California Energy Commission
Dockets Office, MS-4
Re: Docket No. 14-AAER-1
1516 Ninth Street
Sacramento, CA 95814-5512

RE: CEC DOCKET NO. 14-AAER-1, APPLIANCE EFFICIENCY PRE-RULEMAKING

Comments on the Recommendation by the CASE Team for a Maximum Urinal Consumption Level of 0.125 gpf:

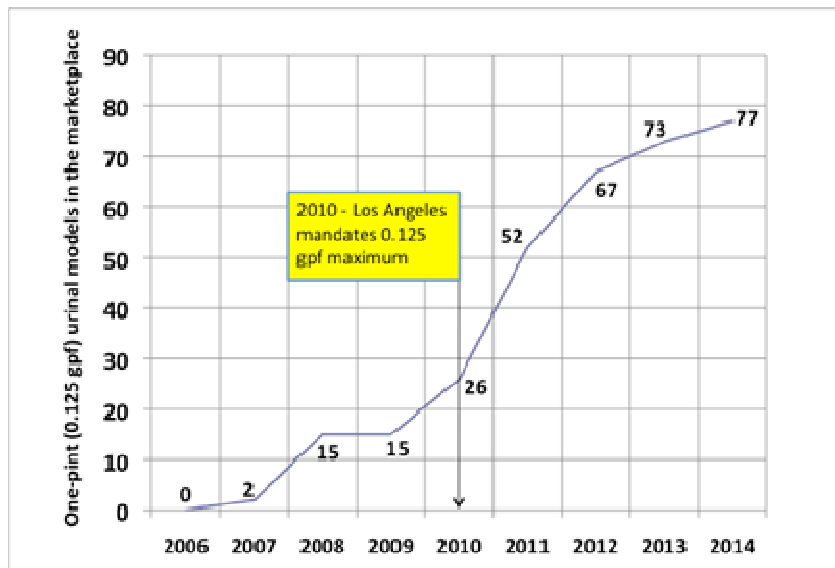
- Urinals flushing at 0.125 gpf were introduced to the marketplace in 2006. Response was initially very slow and the marketplace had limited product availability. It was only in 2010 that product selection was sufficient to gain attention, and in October, 2010 these pint urinals were required for new installations by the City of Los Angeles. (Their experience to date with these fixtures remains undocumented.) Today, only 77 (about a third of all high-efficiency urinal models) certified to the WaterSense specification are at the 0.125 gpf threshold. See the chart below for information on the growth of these models².
